GRONDGEBRUIKBEPLANNING EVALUERINGSVERSLAG

AANSOEK: VOORGESTELDE HERSONERING EN VERGUNNINGSGEBRUIK : PLAAS GOREE 158/71, (BEGRAAFPLAAS) MONTAGU (ASHTON AREA)

Verwysingsnr	15/4/9/9/1	Aansoekdatum	29.01.2020	Verslagdatum	24.11.20
DEEL A: SKRYWER SE BESONDERHEDE					
Naam en van	Jack van Zyl				
Werkstitel	Assistent Bestuurder: Stadsbeplanning				
SACPLAN registrasienommer	AJ1170/2000				
DEEL B: BESONDERHEDE VAN EIENDOM					
Eiendomsbeskrywing (volgens Titelakte)	Plaas Goree 158/71 Montagu (Ashton)				
Fisiese adres		Dorp	Ashton		
Huidige sonering	Nywerheidsone I	Grootte (m2 /ha)	71.46ha (6.7ha)	Is daar bestaande geboue op die eiendom?	J N
Toepaslike soneringskema	Tans: Langeberg Munisipaliteit Geïntegreerde Soneringskema Verordening, 2018				
Huidige grondgebruik	Vakant			Titelaktenommer en -datum	T6170/1999
Is daar beperkende titelvoorwaardes van toepassing?	J	N	Indien JA, lys voorwaarde nommer(s)		
Is daar enige derdeparty voorwaardes van toepassing?	J	N	Indien ja, noem		
Is daar enige ongemagtigde grondgebruik/bouwerk?	J	N	Indien ja, verduidelik

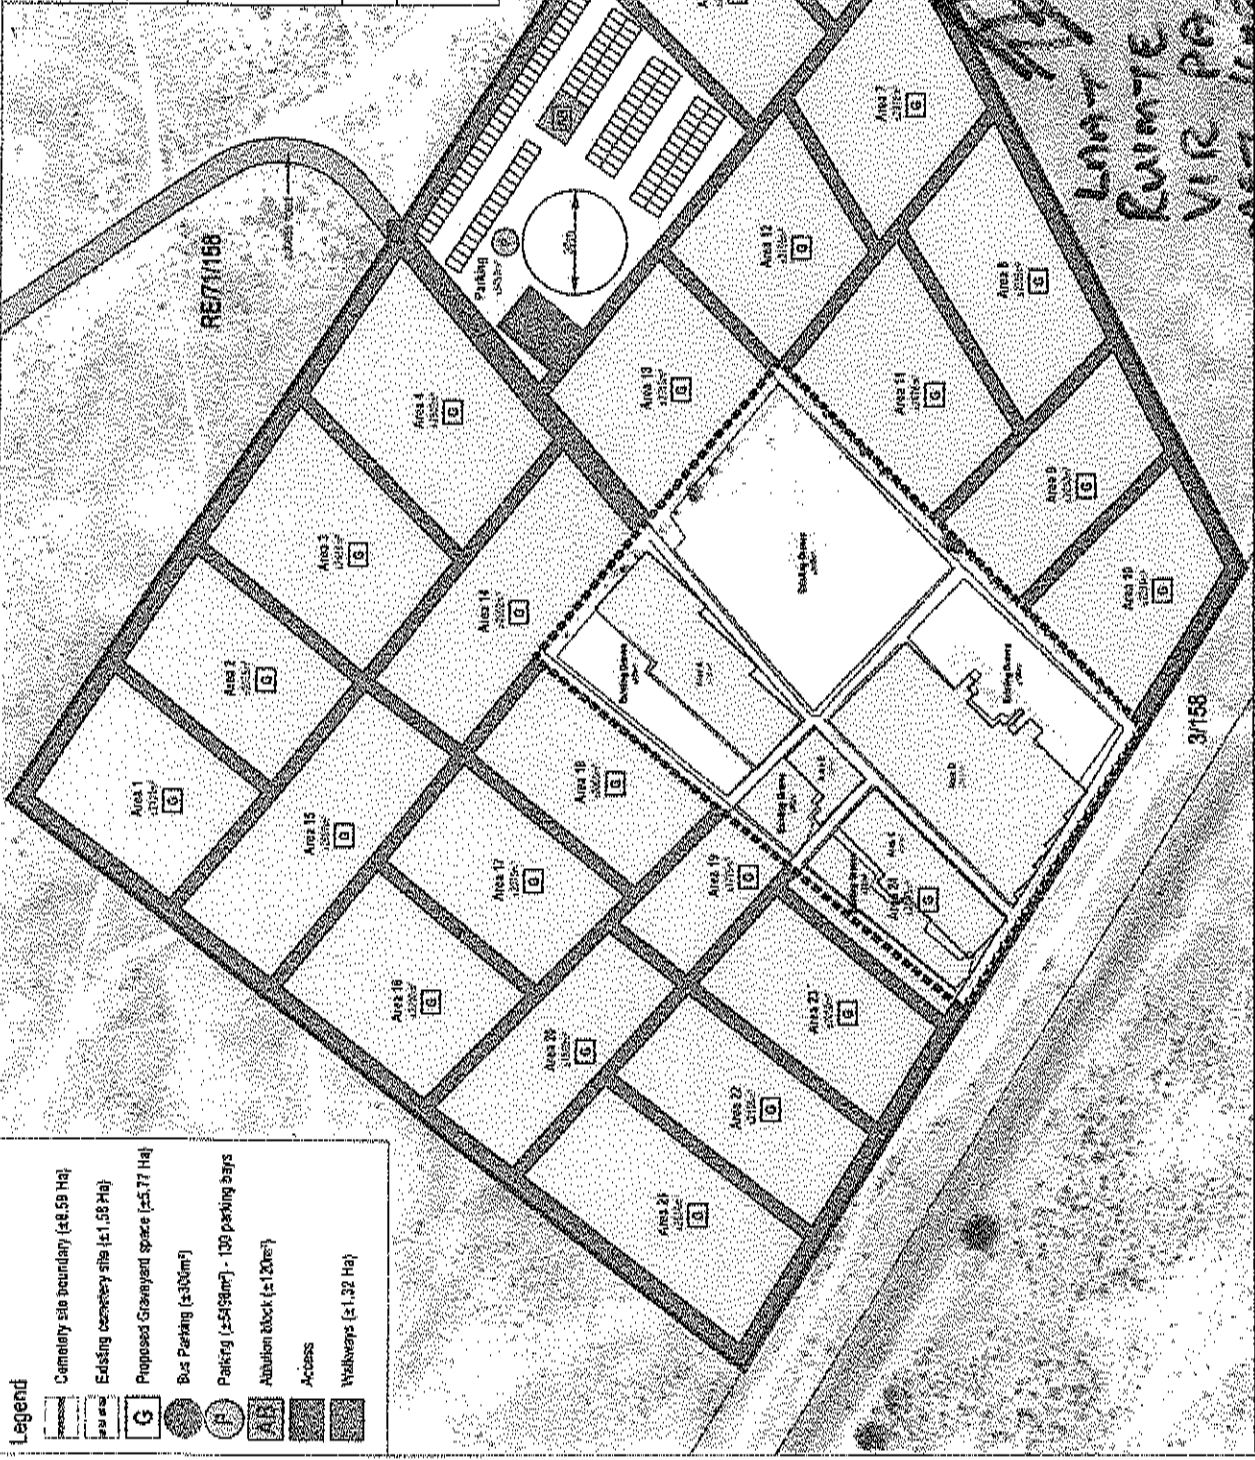
Rioolpomplyn loop al langs die spoorlyn op. Genoegsame spasie moet oopgelaat word sodat die rioollyn nie binne die area van die beraafplaas sal wees nie. Water beskikbaar vanaf bestaande begraaftaas.

Die Elektriese Departement het geen beswaar teen die aansoek nie. Geen grafte mag onder die 11kV lyn gemaak word nie. Daar moet 'n 3m oopruimte weerskante van die lyn gelaat word sodat instandhoudingsvoertuie daar kan ry.

Die hersonering sal 'n groot gedeelte en ontwikkelde nywerheidsgrond in beslag neem. Die uitleg/vorm van die gedeelte is ook sodanig dat dit die uitleg en ontwikkeling van toekomstige nywerheidserwe in die oorblywende nywerheidsgebied in 'n mate kan belemmer. Daar is egter steeds voldoende ruimte vir 'n werkbare uitleg van nywerheidserwe in die toekoms. Ten einde al die potensiële nywerheidsontwikkeling toeganklik te maak, word voorgestel dat die buitefiguur van die begraafplaas effens aangepas word om te verseker dat daar voldoende ruimte is om 'n pad (met 16m reserwe) tussen die oostelike hoek van die begraafplaas en die munisipale rioolsuiweringswerke te kan maak (sien aantekening op Liggingsplan en Terreinuitlegplan in Bylae 1).

1. Die ligging, omvang en terreinuitleg van die hersoneerde gedeelte is soos aangedui op terreinplan gemerk ASH158-71-LBM-TP, met die uitsondering van 'n aanpassing van die buitefiguur om voorsiening te maak vir 'n 16m breë padreserwe tussen die begraafplaas en die munisipale rioolsuiweringswerke..
2. Ingevolge Artikel 17 van die bg Verordening, verval die hersoneringsgoedkeuring en daarmee saam die toegestane vergunningsgebruik indien dit nie binne 'n periode van 5 jaar vanaf die datum van hierdie goedkeuring uitgeoefen word nie.
3. Genoegsame spasie moet oopgelaat word sodat die rioollyn wat langs die spoorlyn lê nie binne die area van die begraafplaas sal wees nie.
4. Geen grafte mag onder die 11kV lyn gemaak word nie. Daar moet 'n 3m oopruimte weerskante van die lyn gelaat word sodat instandhoudingsvoertuie daar kan ry.
